Office Action Summary

10/530,325

TITZ, PETER

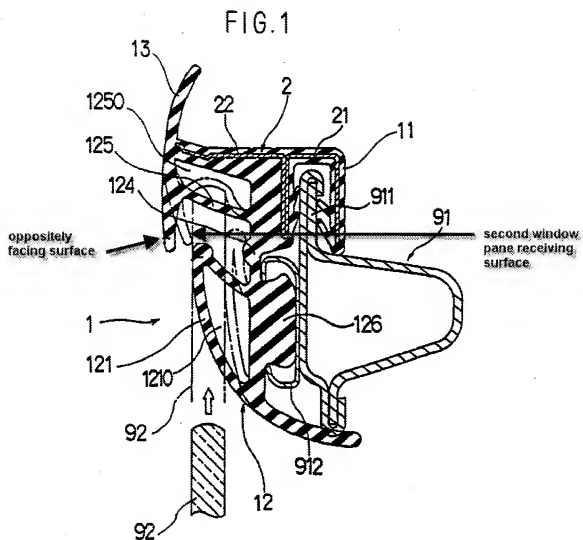
Claims 18, 27-29 and 34 are rejected under 35 U.S.C. 103(a) as being unpatentable over Morita (US 5209019) in view of Nozaki et al. (US 5269101). Morita discloses a method of forming a sealing, trimming or guiding strip 1 for a window frame 91 comprising a flange 911 and a window pane 92 having an interior side and an exterior side, the method including:

extruding a length of material to form part of the strip 1 as set forth in col. 3, ln. 35-37,

the extruded material includes a channel 11 for receiving the flange 911 of the window frame and a rigid reinforcing carrier 2 embedded within the extruded material in a region corresponding to the channel,

the extruded material extends from the channel and has a second window pane receiving surface (labeled below) at the exterior side of the window pane and a generally oppositely facing surface (labeled below) directly visible from the exterior of the vehicle;

and the molded material includes at least one integral formation 126 for securing the molded material to the window frame;

the integral formation 126 includes a plurality of formations (not numbered, but comprising the upper and lower ends of the formation 126) (claim 27);

an elongated rigid member 912 is provided into which a portion of the strip is fitted (claim 28);
